| Model: PT3 | Date: 07-Dec-09 | No.: RC275001c |

| Subject: Firmware Release Note: Main | | Prepared by: K. Yamamoto | |

This RTB has been issued to announce the firmware release information for the **Main**.

Printer Unit Type4545 (C654)

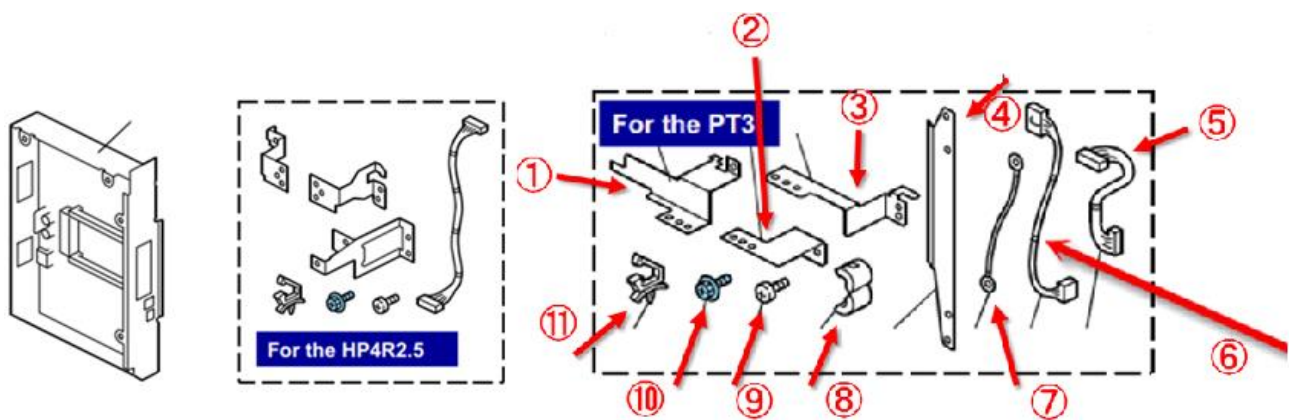
Change/Reason: The following accessories for the Printer Unit Type4545 (C654) for the PT3 were added to the Parts Catalog.
